# TOWN OF ELLINGTON

## ELLINGTON INLAND WETLANDS AGENCY REGULAR MEETING AGENDA MONDAY, JULY 13, 2020 7:00 P.M.

1. IW202004 – MJS Leasing LLC & Chilson Realty Co., owners/ Town of Vernon & Town of Ellington, applicants request for a map amendment and permit to conduct regulated activity for the construction of four full-size soccer fields, parking and access roads, concession and restroom buildings, and associated site improvements on properties along the east side of Windermere Ave near the Vernon town line, at APNs 011-033-0000, 019-005-0004 and 019-005-0005. **(Continued from June 8, 2020 meeting)**
2. IW202005 – Daniel Houlihan, owner/applicant request for a map amendment at 42 Crane Road, APN 068-002-0000. **(Notice requirements met, hearing may commence)**

John, David and I have been discussing some of my preliminary comments on the original plans. These latest plans are a product of that initial discussion. While we are moving in the right direction, there remain a few items to be addressed and some additional items I did not identify in my initial discussions with David. I offer the following wetland comments for consideration prior to Monday's wetland meeting:

**COMPILATION PLAN**  
**EXISTING CONDITION PLAN**  
**LAND OF**  
**DANIEL HOULIHAN**  
 APN 068-002-0000  
**42 CRANE ROAD**  
**ELLINGTON, CONNECTICUT**

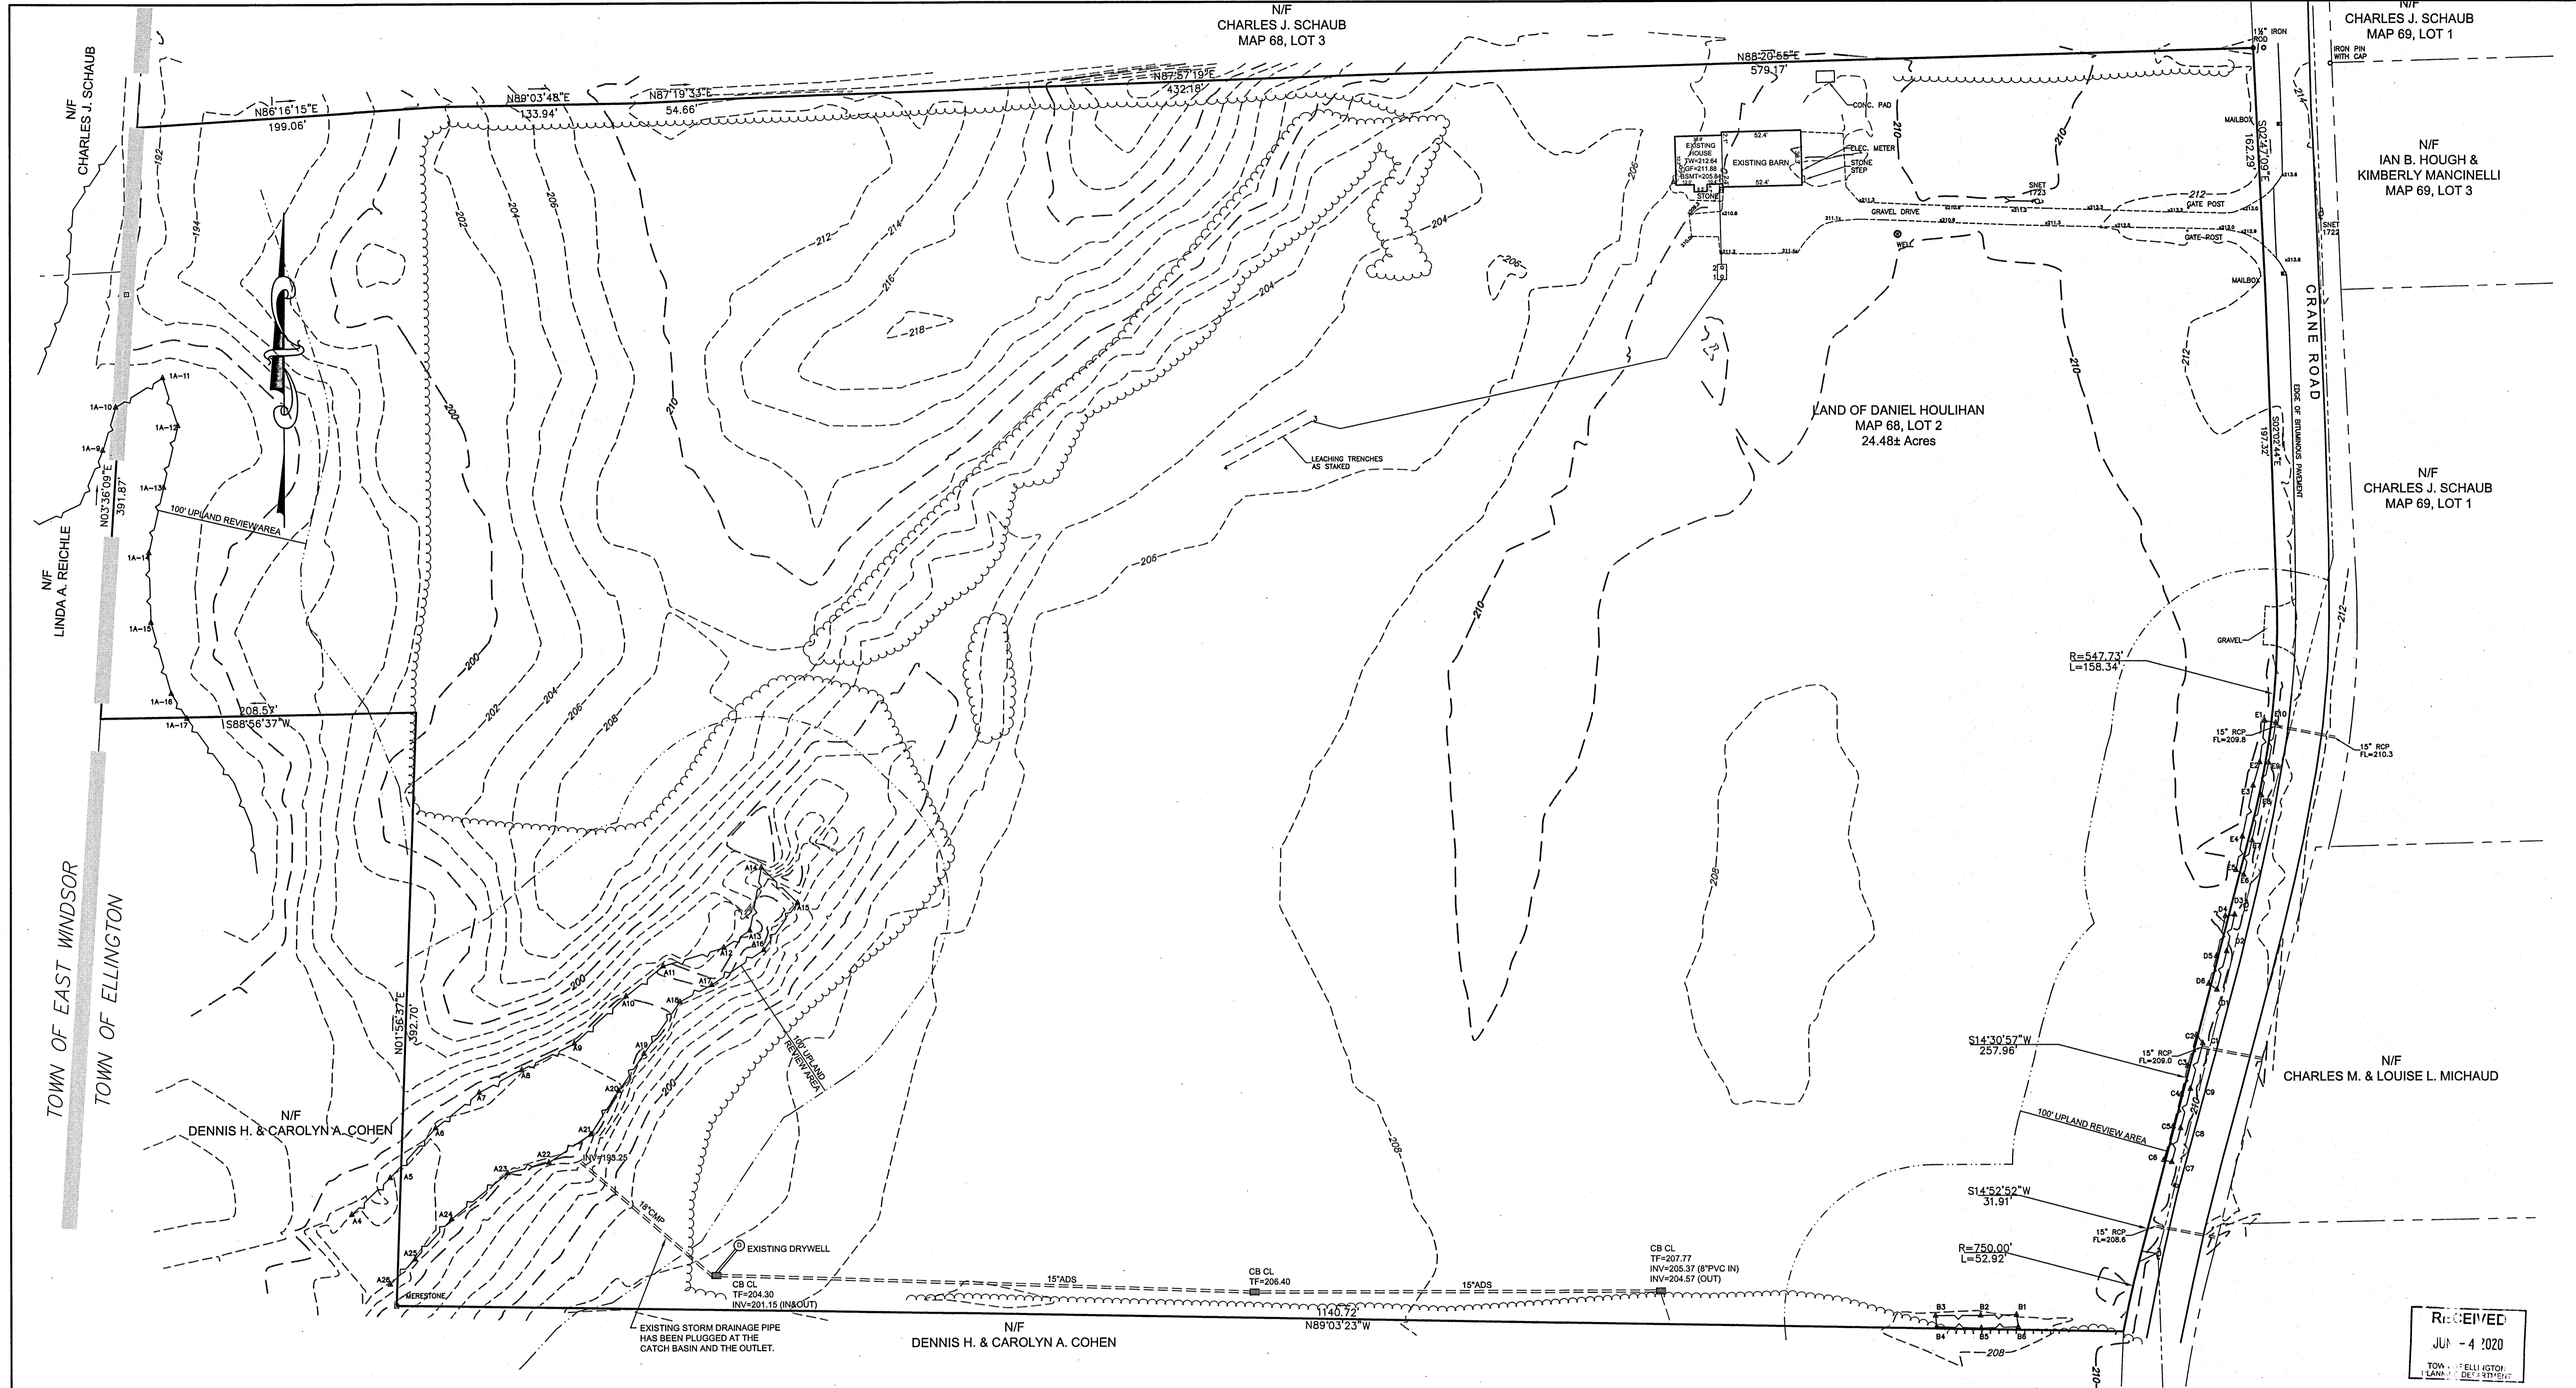
- Particularly on the east side, slumping was noted on the steeper slopes surrounding the wetland delineated by flags numbered RES-A4 to A26.

The wetland delineations shown on the “Existing Conditions Plan, Land of Daniel Houlihan, APN 068-002-0000, 42 Crane Road, Ellington, Connecticut”, revised 11-19-2019, accurately represents wetland boundaries and soil conditions observed on the 42 Crane Road parcel.
